To: All U.S. Volvo Retailers
Re: Delivery Action D10045: S60 Wheel Hub Bolts

**Delivery Action D10045: S60 Wheel Hub Bolts
Model Year 2021**

D10045 – Wheel Hub Bolts

Check & repair instruction Wheel hub bolts on vehicles with 2WD

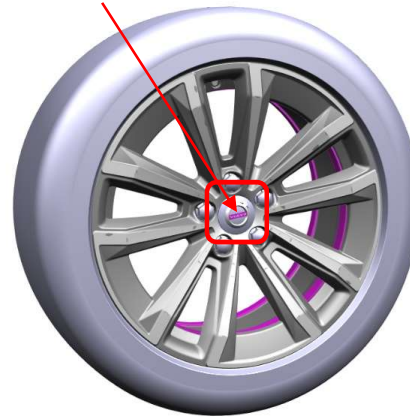
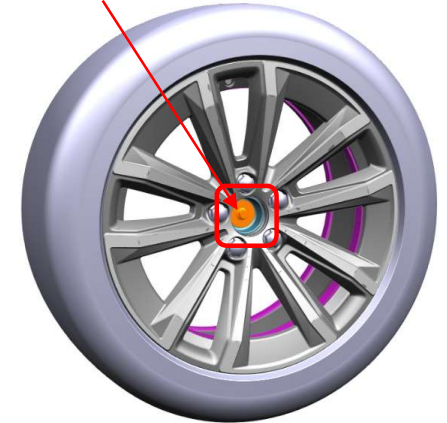
There is a risk that the bolts securing the wheel hub to drive shaft may not be torqued according to specifications.

A customer might experience a metal-to-metal noise in the front wheels on 2WD vehicles and on any wheel on AWD and PHEV variants.

Remove the wheel cap with the Volvo logo of both front wheels.

- Inspect if bolt is torqued correctly using a torque wrench set on 50 Nm.
- If the bolt torque is less than 50 Nm, loosen the bolt and re torque the existing bolt to 45Nm+90deg.

Repeat this step for the opposite front wheel.
